### **ADDENDUM #1**

**To:** All Companies Interested in Submitting a Bid  
**From:** Heather Mell, Purchasing Agent  
**Bid:** Sternberg Decorative Lights (Bid #PUR1016-069); Dated: November 2, 2016  
**Subject:** Addendum #1 (1 page)  
**Date:** November 10, 2016

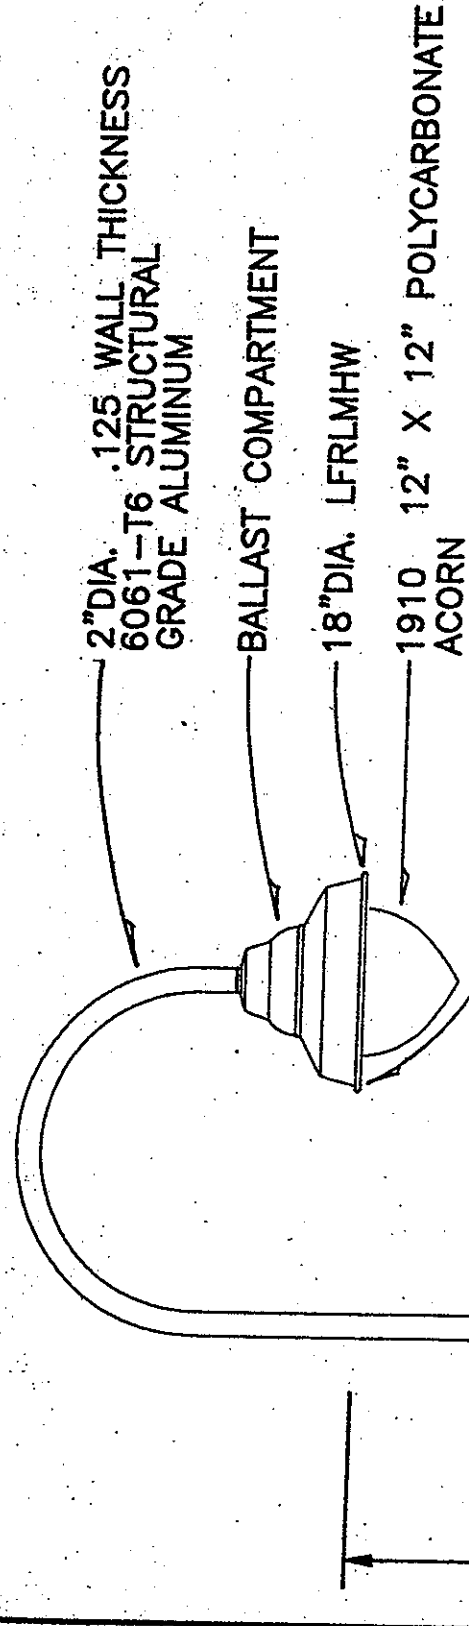
**Question:** What is the mounting orientation and location of the twin head assemblies?

Item No 1. a drawing is attached as page 2 of this addendum. Light is at 16', handhole is on street side, bolt pattern is parallel with street.

Item No 2. A picture is attached as page 3 of this addendum. Street side light is at 16', backside light is at 10', handhole is on street side, bolt pattern is 45 degrees from parallel with street.
